REPLACING PAGE ADDENDUM

**KS-16831 AMPLIFIERS
INSTALLATION AND MAINTENANCE**

1.001 This addendum supplements Section 024-175-200, Issue 1. The attached page must be inserted in the section in accordance with the filing instructions above.

Fig. 4 - Amplifier KS-16831, List 1, Schematic

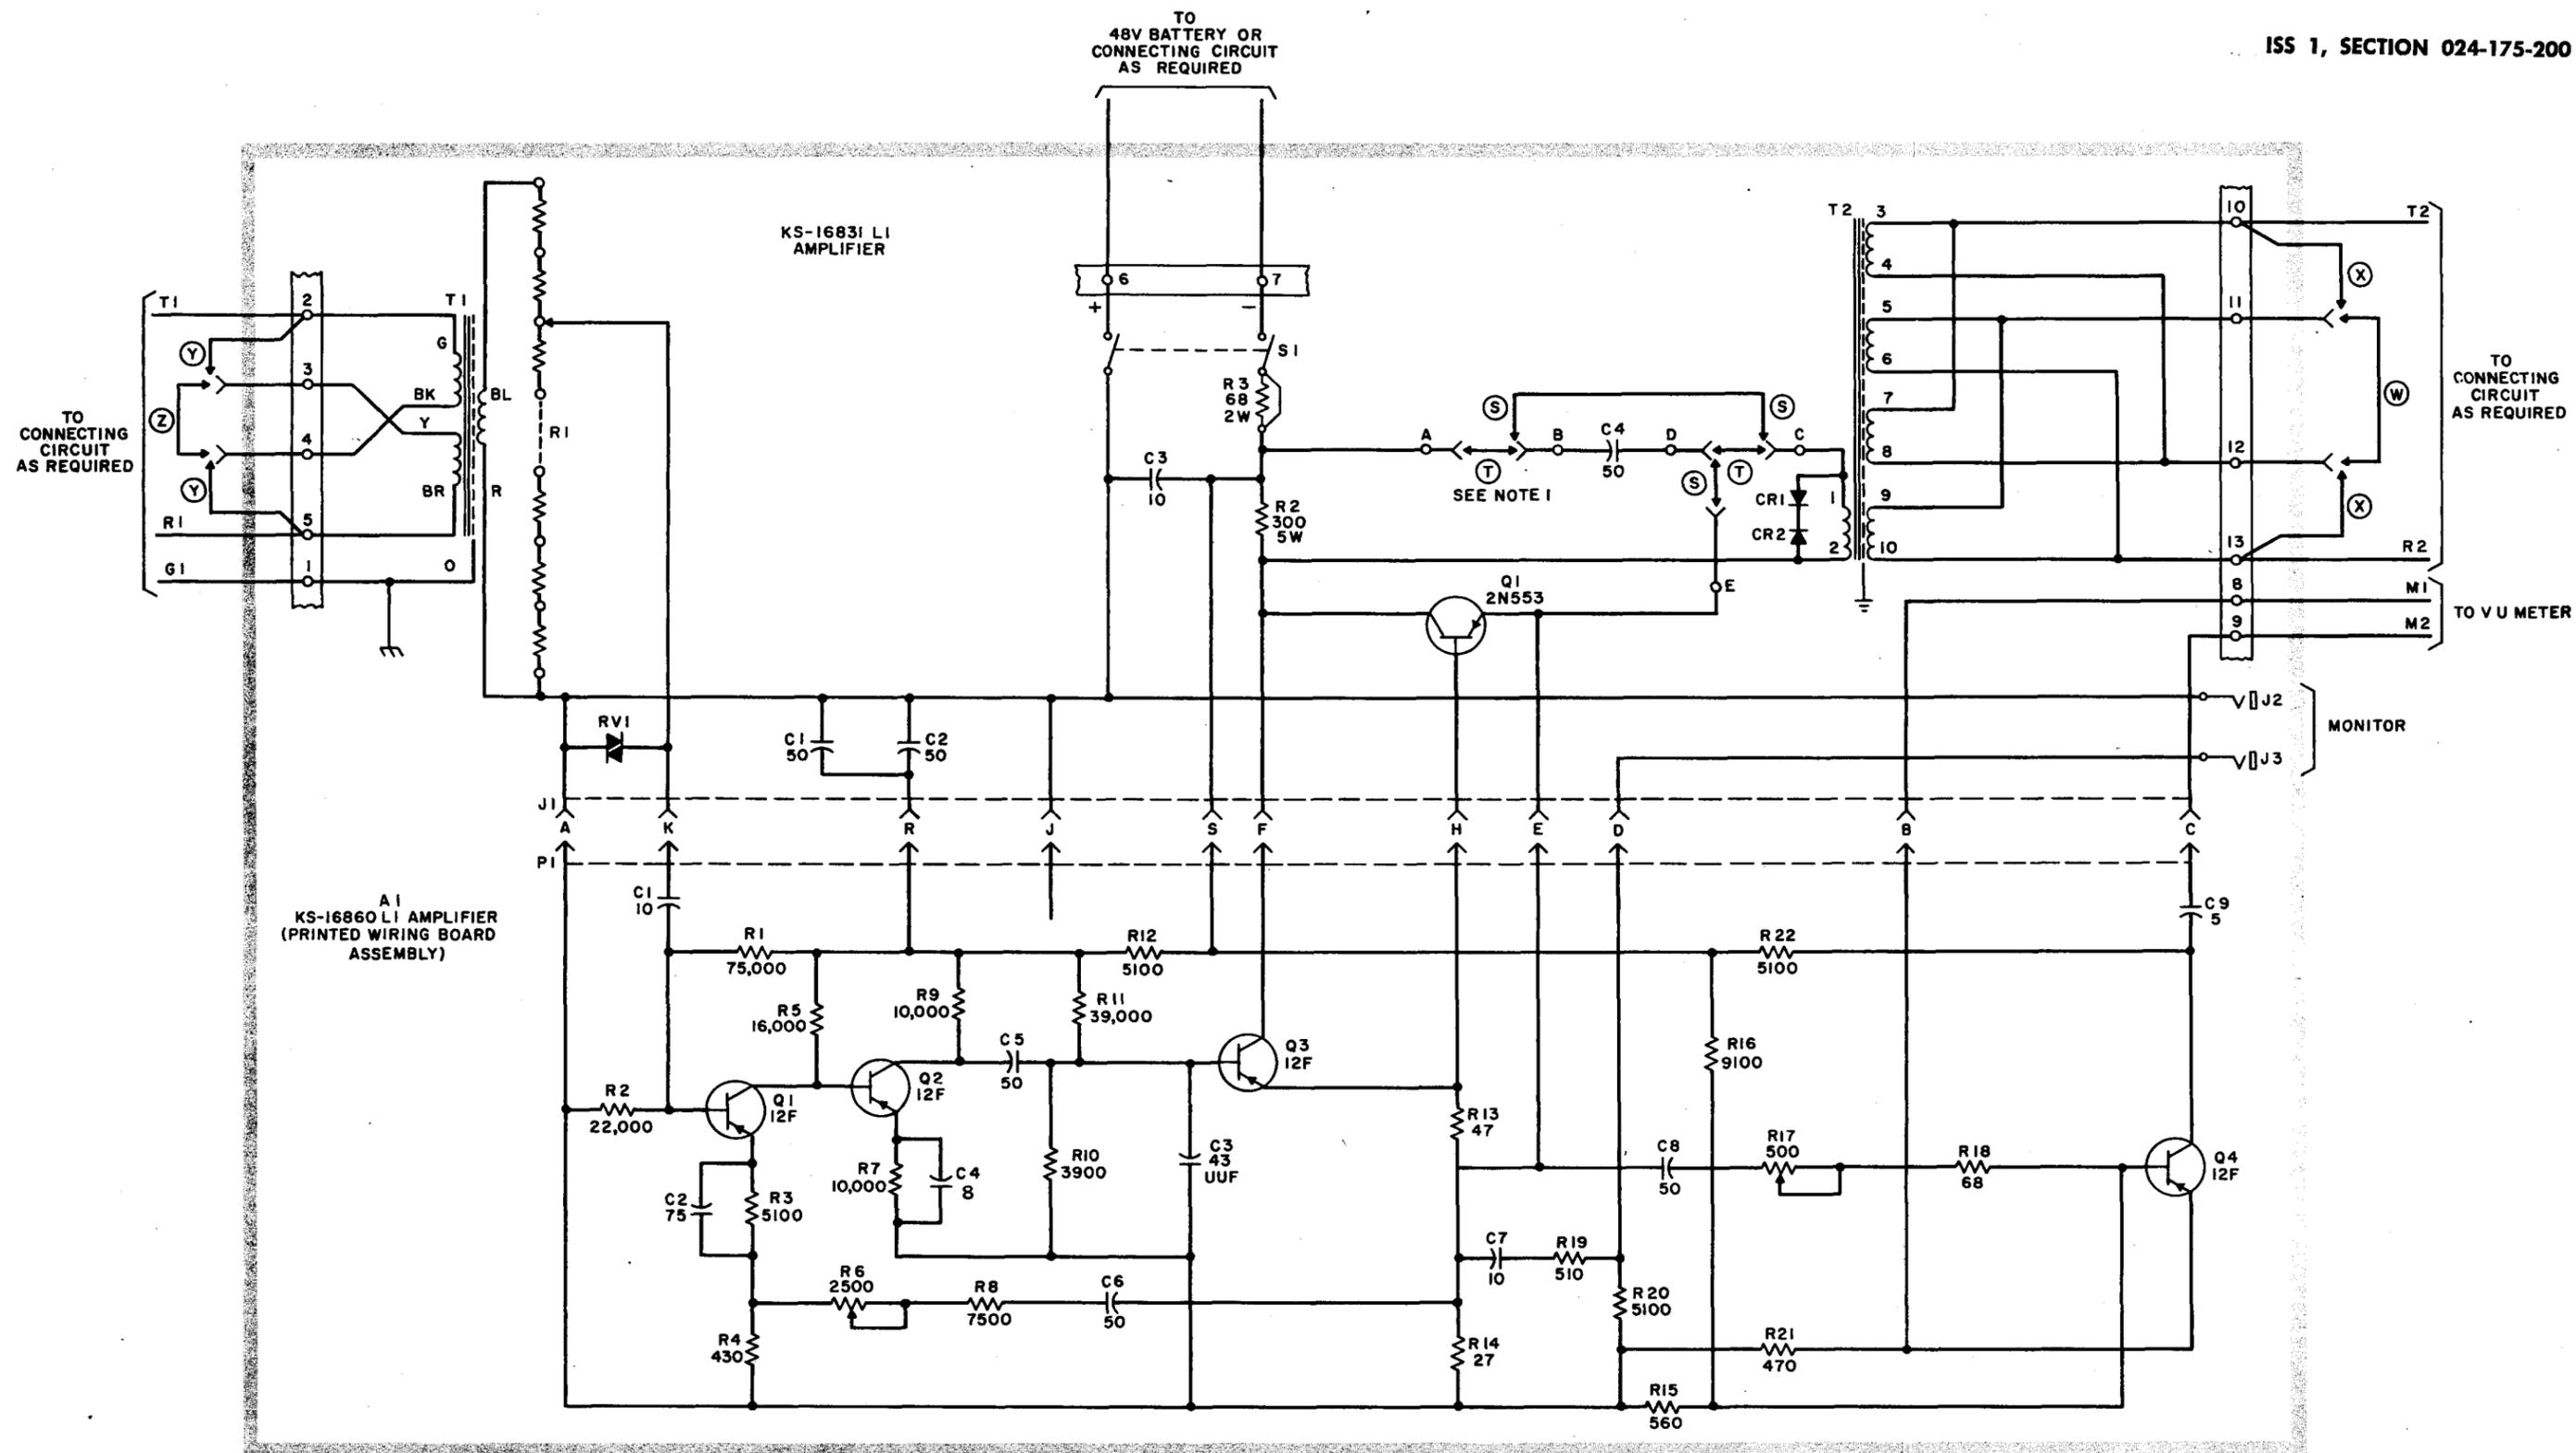
1.002 This addendum is issued to show a change in Capacitor C4 of KS-16860, L1 amplifier printed wiring board assembly from 50 mf to 8 mf.
